LATHAN
ARCHITECTS
LATHAN ■ BRYANT ■ CALMA

ADDENDUM NO. 2
ADDITION AND RENOVATION FOR FLOMATON ELEMENTARY SCHOOL
PACKAGE A: MEDIA CENTER AND CLASSROOM ADDITION
DCM NO. 2021011 PSCA NO. 9167
Architect Job No. 21-04A
March 29, 2022

The Plans and Specifications are hereby amended. The following supersedes all contrary and/or conflicting information and is made part of the contract documents.

1 SYSTEMS PLAN
1/8" = 1'-0"

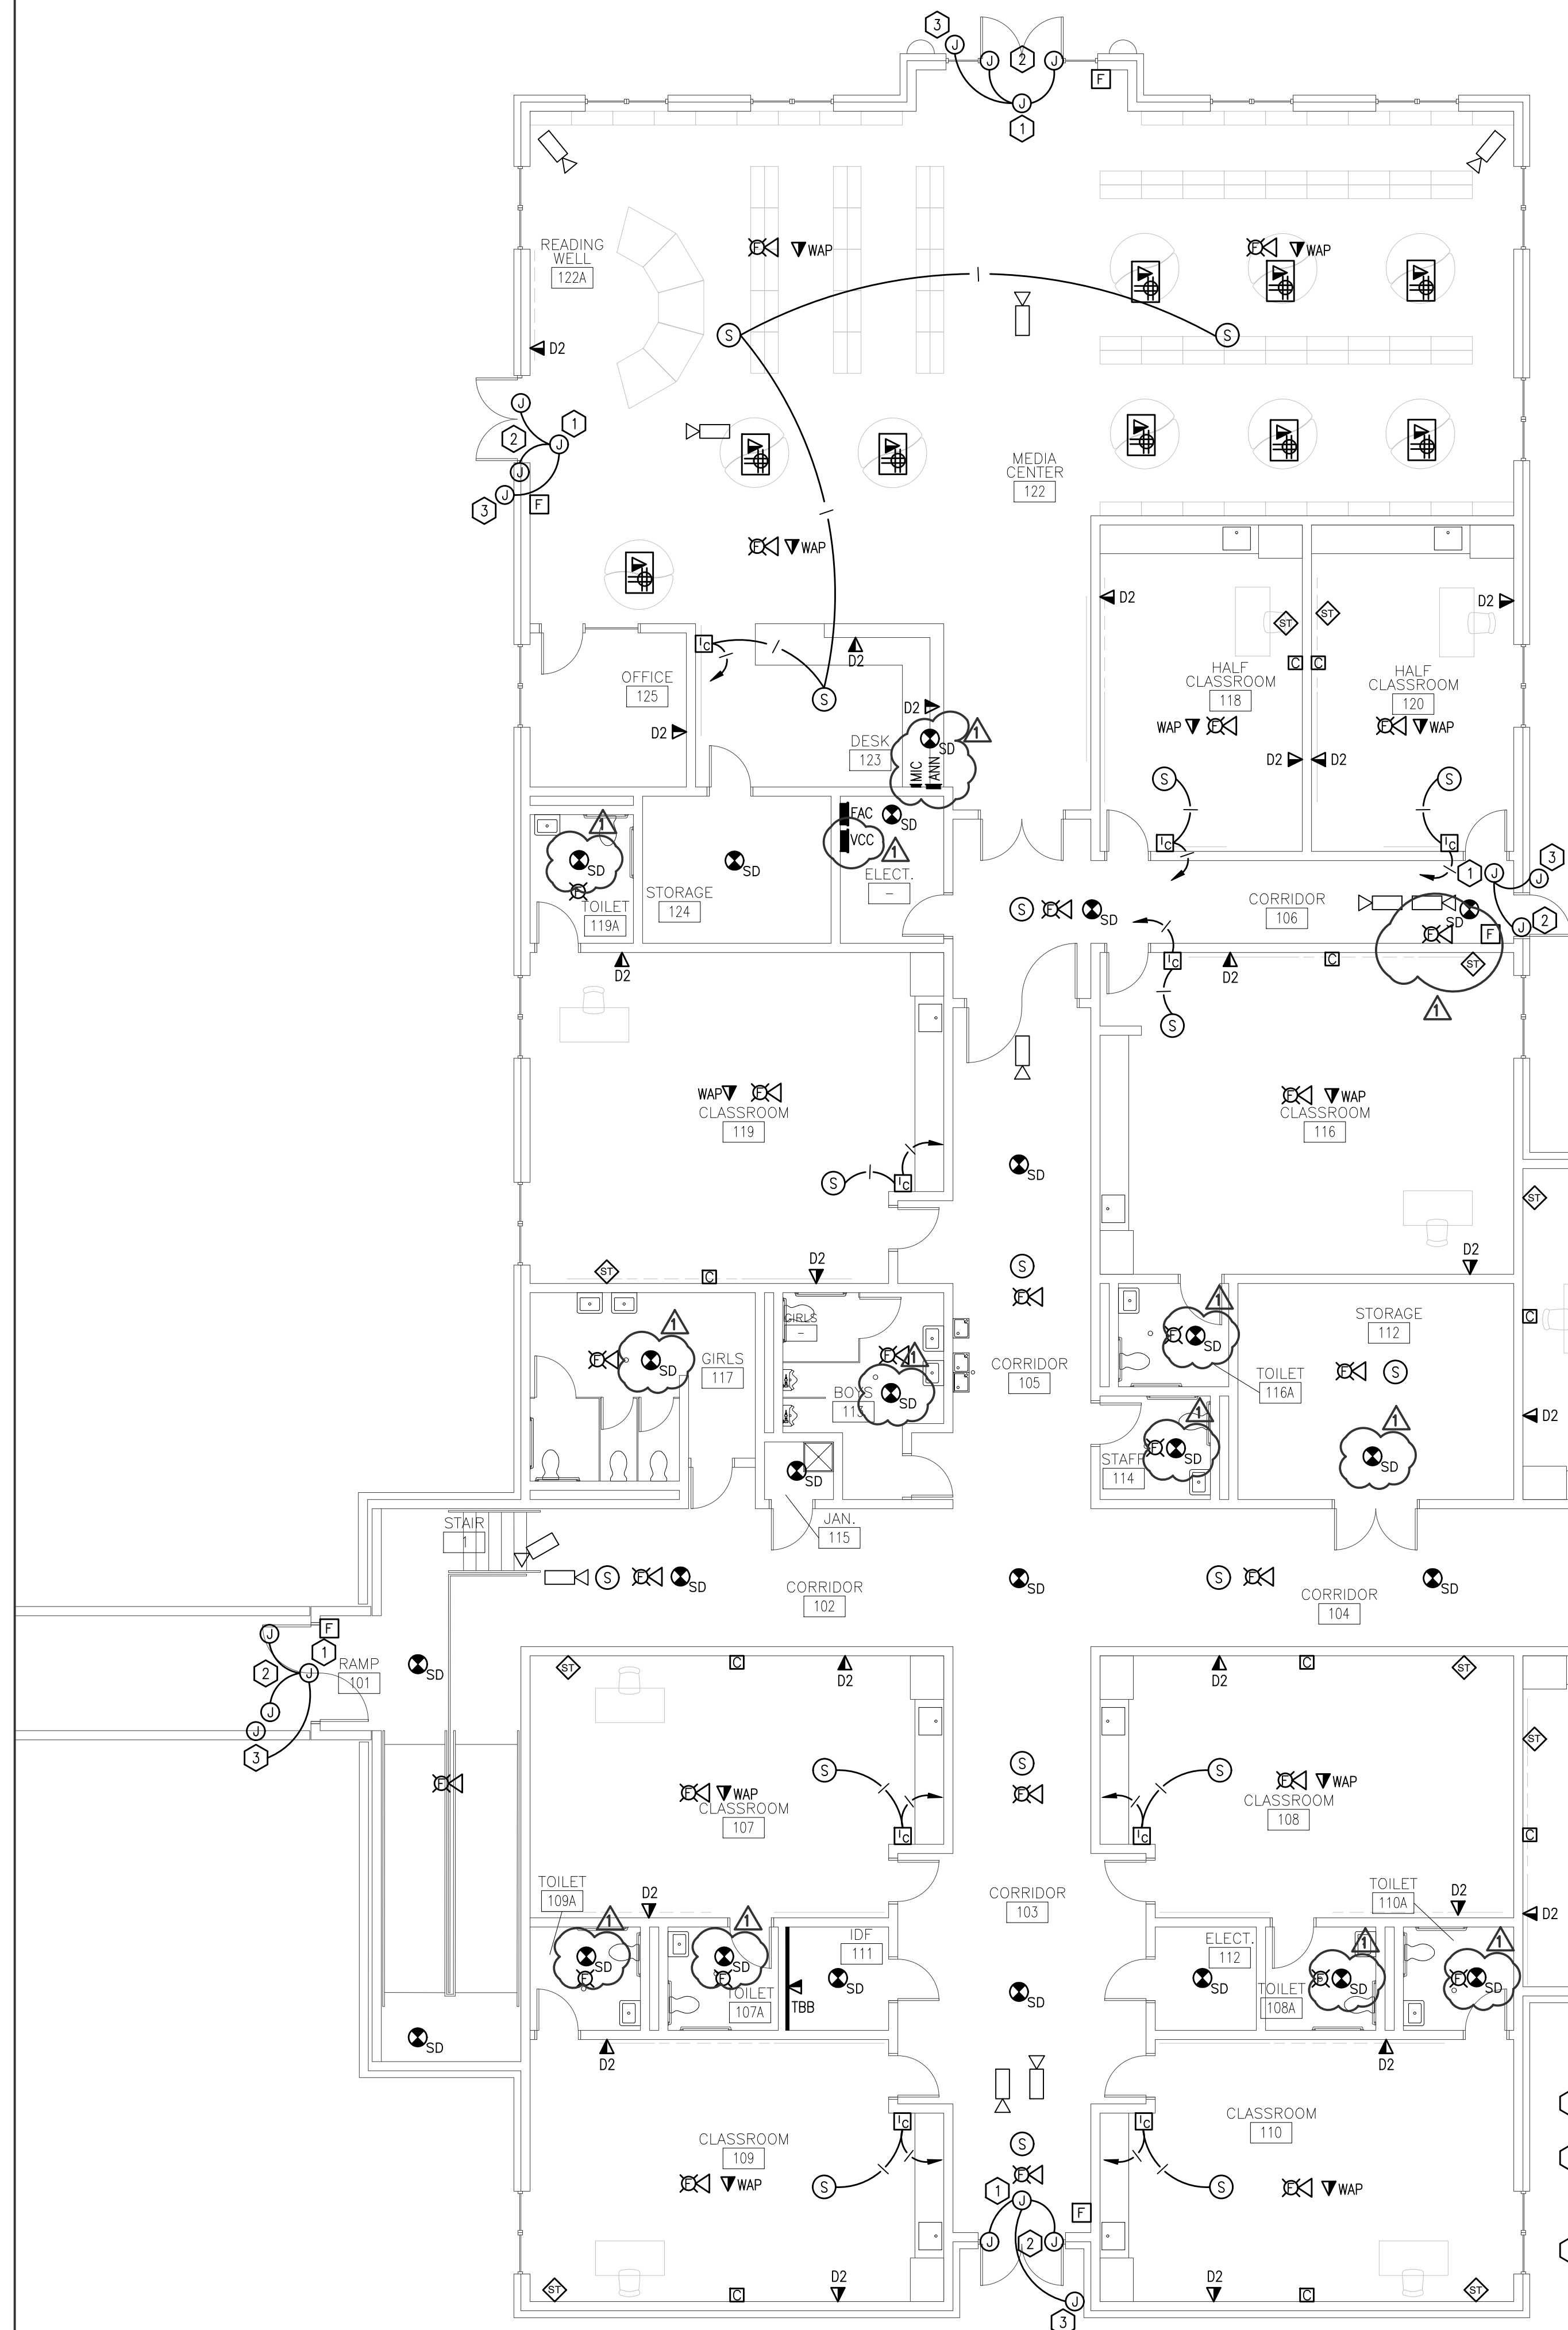
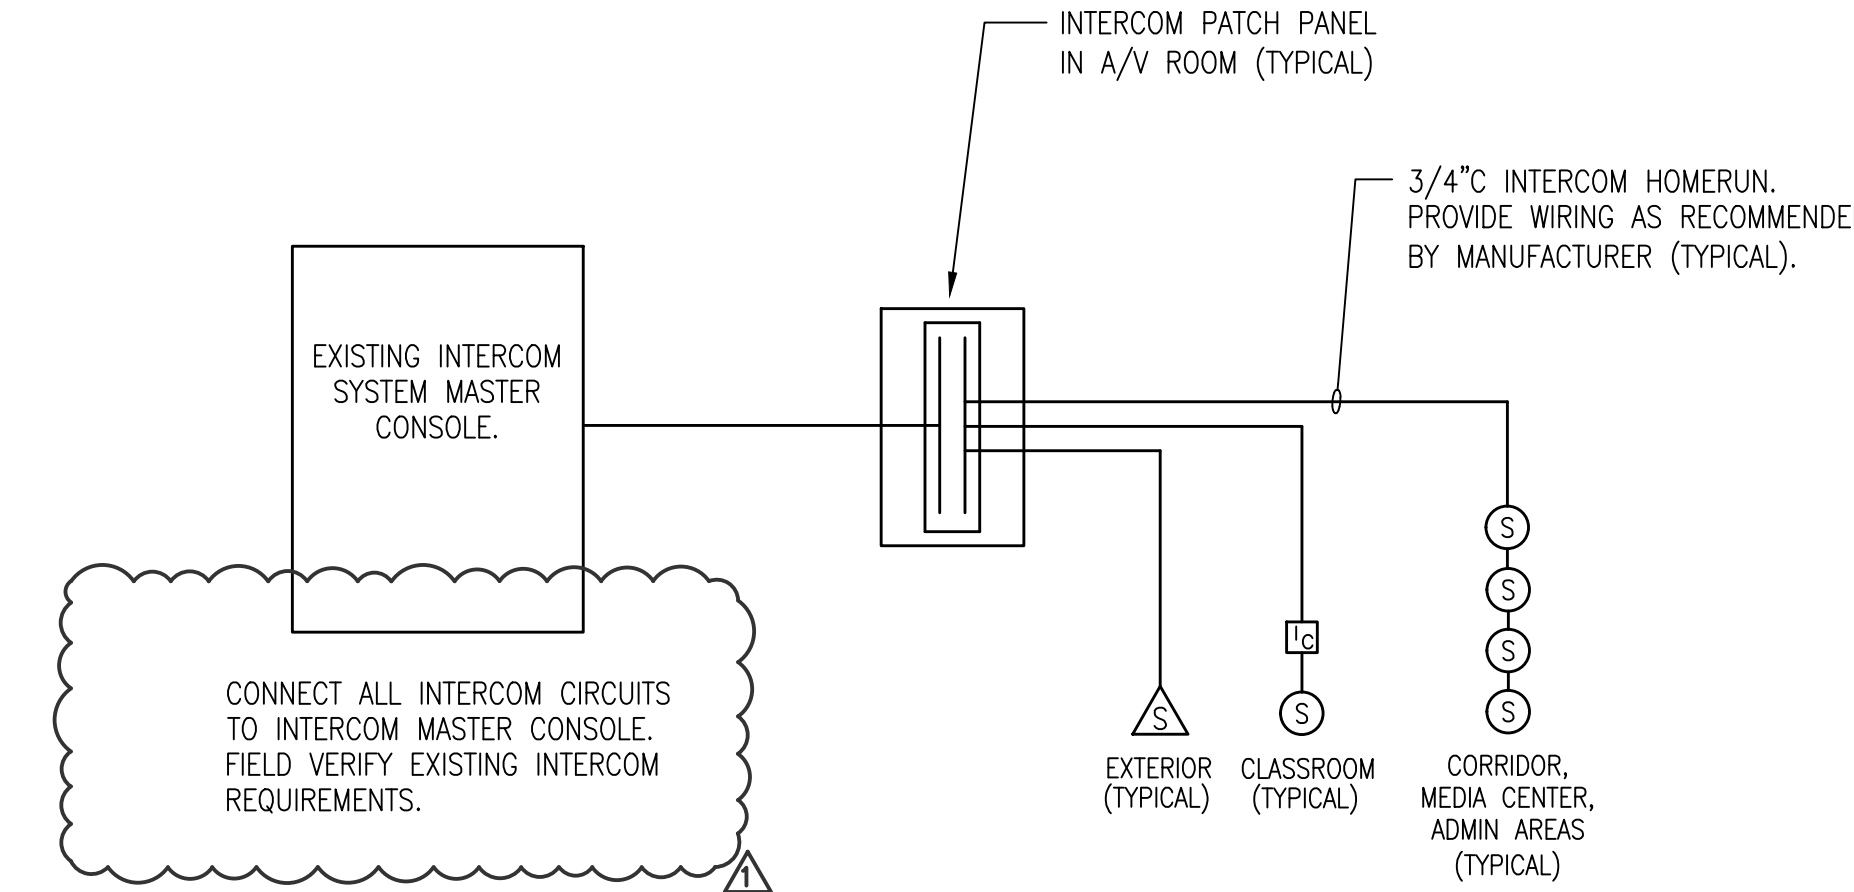
5. E3.1 – Systems Plan – fire alarm riser diagram keynotes added and fire alarm modified.
6. E4.0 – Electrical Panel and Equipment Schedules – AHU #1 revised into two units, Panel 2P1 has been changed to MLO on the panelboard schedule, and the ground sizes have been verified and revised.
